**FINAL PLAT OF
 THE LAKES AT UNIVERSITY PARKS
 ADDITION, PHASE FOUR, LOTS 1-49,
 BLOCK 6; AND LOTS 1-42, BLOCK 7
 TO THE CITY OF WACO, MCLENNAN
 COUNTY, TEXAS**

Purpose: Review by City of Waco.

REF.: “Final Plat of the The Final Plat of The Lakes at University Parks, Phase IV, to the City of Waco, McLennan County, Texas”

Project Number: 20-00037

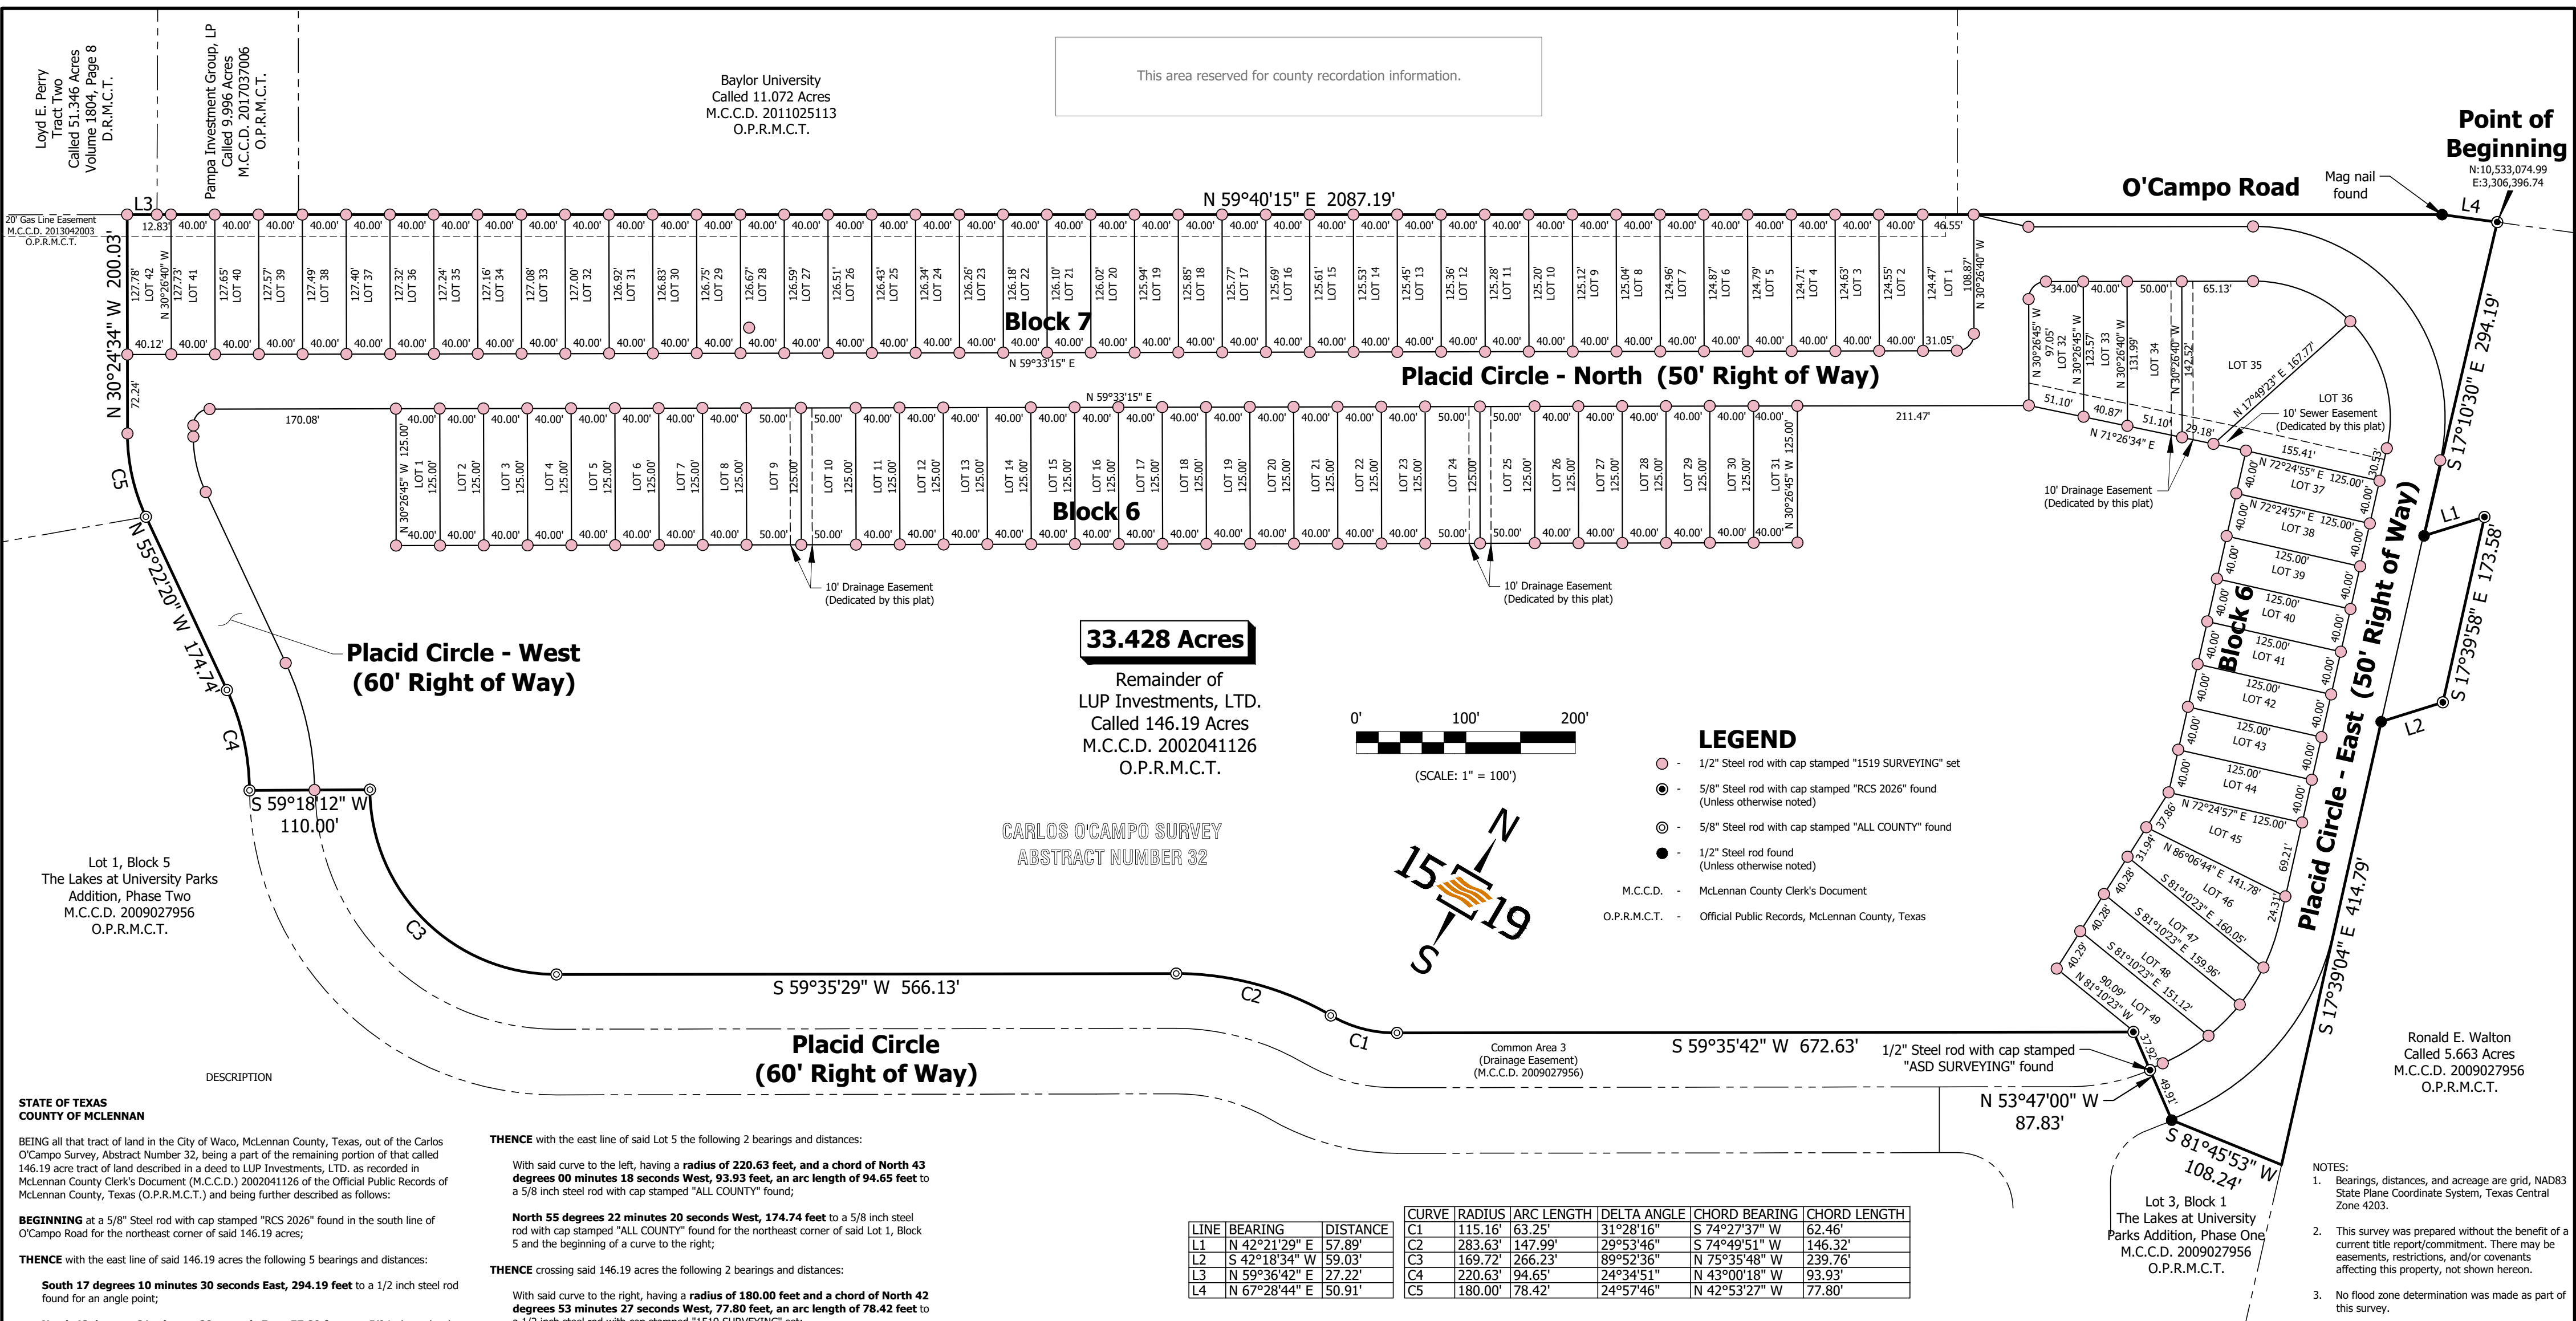
1. The owners of the property need to sign the plat.

2. Please add utility purveyors to plat.
3. The surveyor needs to sign and seal the plat and set the monuments as shown.
4. The invoice for your standard plat application is now available. Please submit a payment of \$300.00 using the Citizen Self Service online portal.

5. Please upload a current McLennan County Tax Certificate showing no taxes are due from the previous year.
6. Please contact Mary Henley (254-750-5657) for street name approval and show approved names on the preliminary plat submitted for signatures. Typically, developers are asked to submit five potential names for each street in the event the first choice is not available or approved.

7. Please add a note to the plat that when development plans are submitted, sidewalk construction around Placid Circle will be required.
8. The remainder tract (containing common area and lake) should be included in the plat as a lot and block and hatched or otherwise annotated as to its purpose.

9. Please add all existing easements to the plat.

10. Lots adjacent to lake not included in drainage calculations.
11. Provide original drainage study verify this plan is compatible. Downstream conditions indicate there is no excess capacity to in system to get runoff to Brazos River.

12. Provide riprap detail for flumes including d-50 and depth.
13. Does sidewalk end at Placid Circle W-N intersection?
14. North-West intersection – minimum local curve radius is 150’

15. Bend in North – minimum local curve radius is 150’
16. Junction of O’ Campo, Placid Circle North and Placid Circle East is problematic, please reconfigure.

17. Plan-Profile details for Flumes A, B and C are missing.
18. Provide cross-section details for flumes including adjacent grade and hydraulic capacity of flume and easement for 2-, 10- and 100-year events.

19. Street section detail – City of Waco Standard Detail ST-2 or Sheet 17.
20. Please provide lot grading plans including FFE for each lot.

21. Subdivision Ordinance, Appendix B 5.205: D) Local street 125- foot offset, centerline to centerline; the intersection of Placid Circle with S. 4th Street is too close to the intersection of O' Campo Ave with S 4th Street. The separation between two local road intersections must be at least 125 feet, centerline to centerline. This current proposed roadway alignment for Placid Circle is not allowed. Recommendation: Placid Circle stay as one continuous roadway looping around the lake with an extension of S 4th Street to provide secondary access.

22. Subdivision Ordinance, Appendix B 5.205: G) Curve requirements: Local street shall have a minimum centerline curve radius of 150 feet; any deviation from the minimum curve radius may be allowed if a knuckle or cul-de-sac is provided to widen the roadway at that point.

23. Please clarify if there is intent to continue Placid Circle in a westerly direction at Lot 42, Block 7. A square corner instead of a knuckle is not allowed per the minimum curve radius requirement.

24. Existing sidewalk along Placid Circle (south side of Lake) needs to be extended to meet with proposed sidewalk at beginning of extension of Placid Circle (west side of Lake). This is not shown in construction plans.

25. Sidewalk along at least one side (lake side) of Placid Circle extension is required to continue the pedestrian loop around the lake.

26. Plat is missing the easement for the existing water line. Plat nor plans indicate how or if this easement will be abandoned.
27. Water and sewer mains should be located with the limits of pavement.
28. Water services should be placed in the middle 2/3 of lots and sewer services should be placed on downstream side of lot.
29. Maximum distance between manholes allowed is 450 feet.
30. Sewer main depth minimum is 6 feet.
31. Sewer main cannot cross to other lane of traffic.
32. Provide clarification for why sewer line is upsized to 12".
33. Provide capacity analysis and impact on existing sewer system.
34. On Sheet 07: Water line crossing storm drain will be required to be placed in a casing
35. Sheets 12, 13: Show limits of waterline to be abandoned and how it will be abandoned.
36. Sheet 14: Update sewer line alignment

37. If there are more than 30 homes there will need two entrance and exit points. They shall be placed at a distance apart equal to not less than one-half of the length of the maximum overall diagonal

dimension of the property or area to be served. The 31st home cannot be built until there are two entrance and exit roads.
